## SITE INSTRUCTION # 4

Project: McRae Building  
553 Bonaccord Street,  
Peterborough, Ontario

Project No: 16033

#### 1. Sanitary Sewer Arrangement West Wing:

Drawing Title: ENLARGED UNDERGROUND PLUMBING PLAN - WEST WING

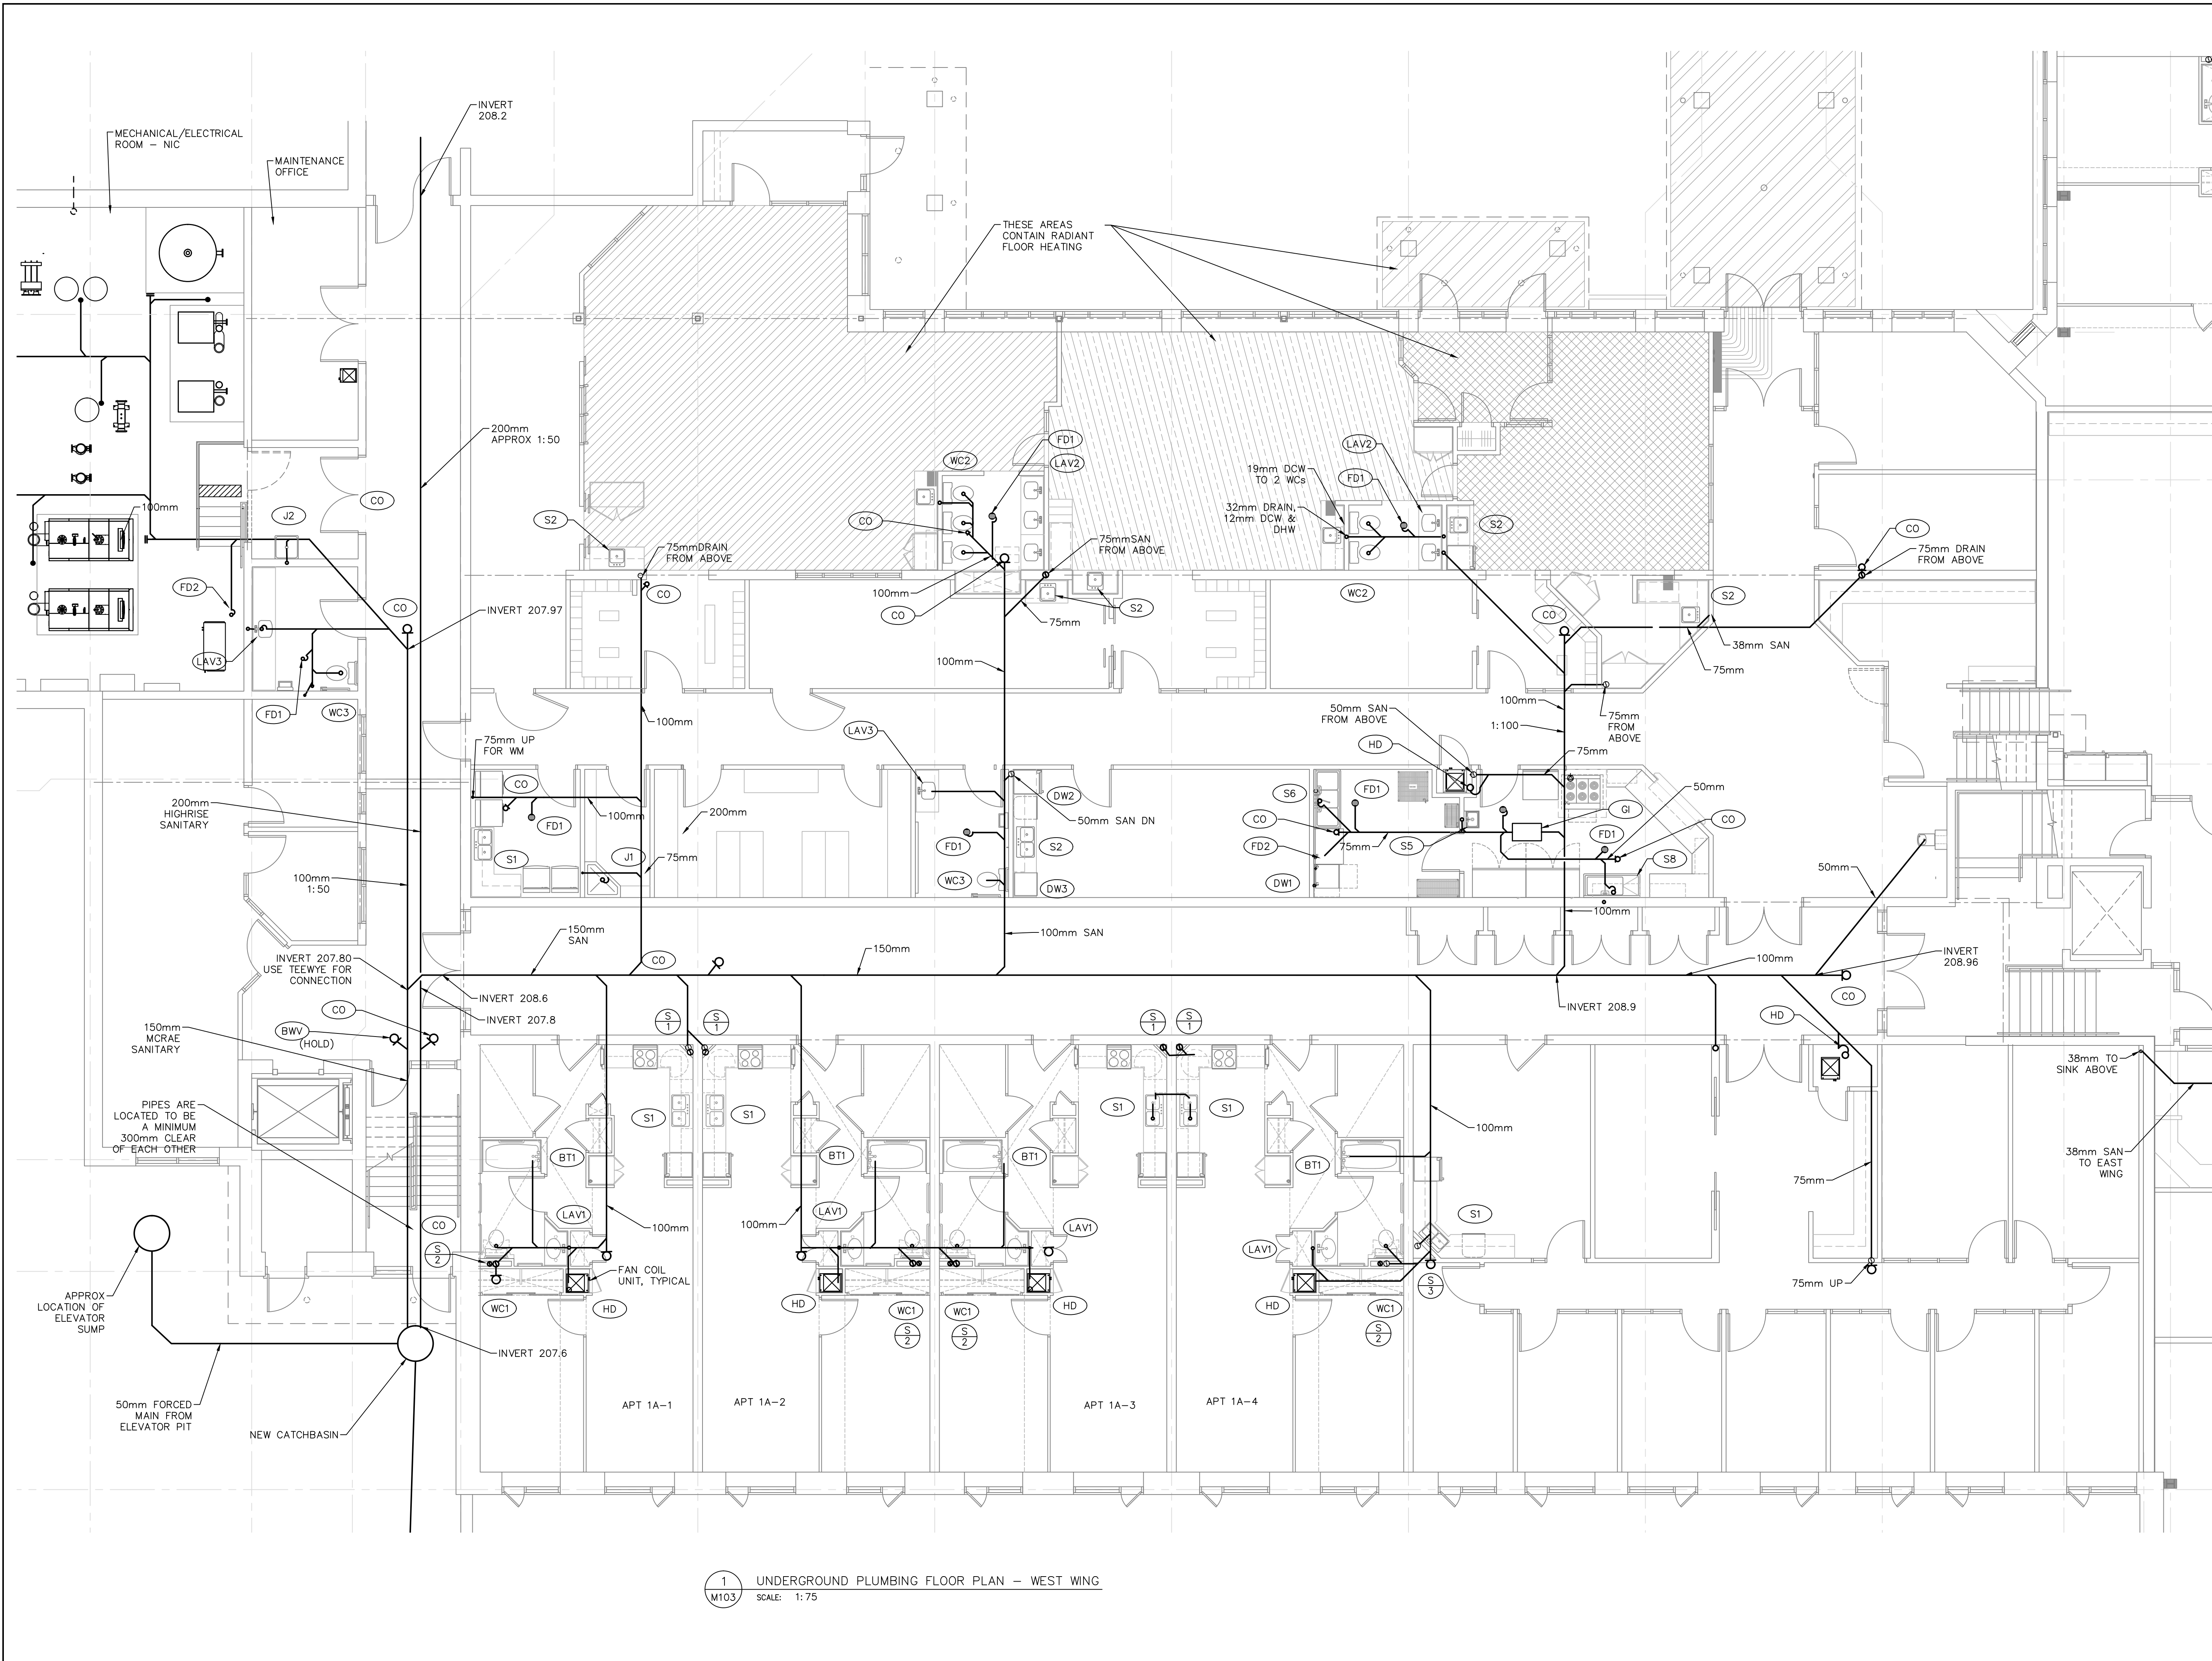
See attached drawing for re-arrangement of sanitary sewer, now exiting the building at the south west corner of the building.
